<b>Customer</b>	: CU-DAR001 Dart Helicopters Services	<b>Drawing Name</b>	: BASKET RIB
<b>Job Number</b>	: 47073		
<b>Estimate Number</b>	: 10404		
<b>P.O. Number</b>	:	<b>Part Number</b>	: D31663
<b>This Issue</b>	: 08/04/2009	<b>Drawing Number</b>	: D3166 REV A2
<b>Prsht Rev.</b>	: NC	<b>Project Number</b>	: N/A
<b>First Issue</b>	: / /	<b>Drawing Revision</b>	: A2
<b>Previous Run</b>	: 46629	<b>Material</b>	:
<b>Written By</b>	:	<b>Due Date</b>	: 14/04/2009
<b>Checked &amp; Approved By</b>	: <u>Julie Dawson</u>	<b>Qty:</b>	6 Um: Each
<b>Comment</b>	: Est. A 02.08.23 New issue KJ Est Rev:B 09-01-23 as per DEO D3166-A2 DD verified by:EC

DESIGN #	DRAWN BY CP	DART AEROSPACE LTD HAWKESBURY, ONTARIO, CANADA	
CHECKED #	APPROVED #	DRAWING NO. D3166	REV. A SHEET 1 OF 1
DATE 02.07.10		TITLE BASKET HOOP	SCALE NTS
A	02.07.10	NEW ISSUE	
A1	04.04.08	38+/-1 WAS 36.0

DRAWING NO. D3166	TITLE BASKET HOOP	REV A1	DART AEROSPACE LTD ENGINEERING ORDER		D.E.O. NO. D3166-A-2	SHEET NO. 1 OF 1	SCALE NTS
DRAWN AJS	CHECKED <i>[Signature]</i>	MFG. APPR. <i>[Signature]</i>	APPROVED <i>[Signature]</i>		DE APPR. <i>[Signature]</i>		
DATE 08.12.11	DATE 08.12.15	DATE 08/12/15	DATE 08/12/16		DATE 08.12.16

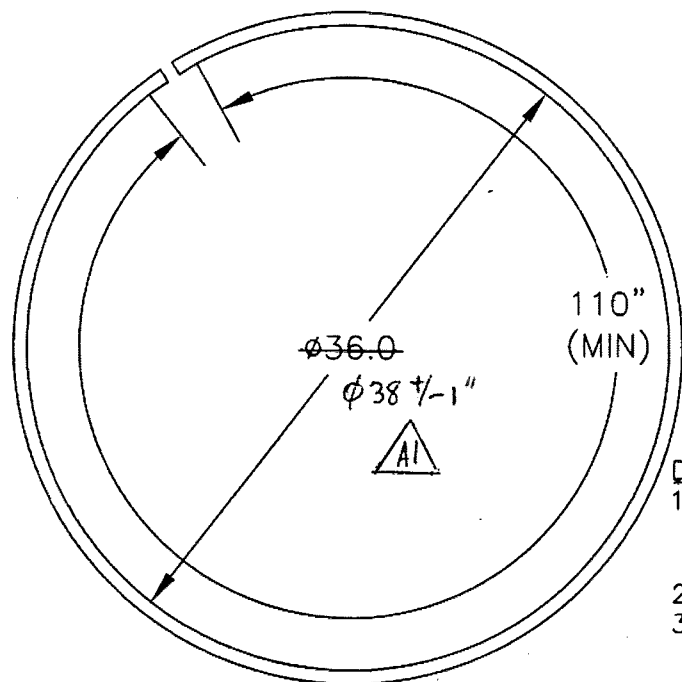
1) MODIFY MATERIAL NOTE FOR D3166-1 AS SHOWN:

2) MODIFY MATERIAL NOTE FOR D3166-3 AS SHOWN:

REASON: SEE PAR 08-005

IS:

1) MATERIAL: AISI 304/316 SS, 3/4 X 3/4 X 0.065 WALL SQUARE TUBING,  
60.00" LONG  
REF. DART SPEC M304TS0.750W.065

IS:

1) MATERIAL: AISI 304/316 SS, 3/4 X 3/4 X 0.065 WALL SQUARE TUBING,  
120.00" LONG  
REF. DART SPEC M304TS0.750W.065
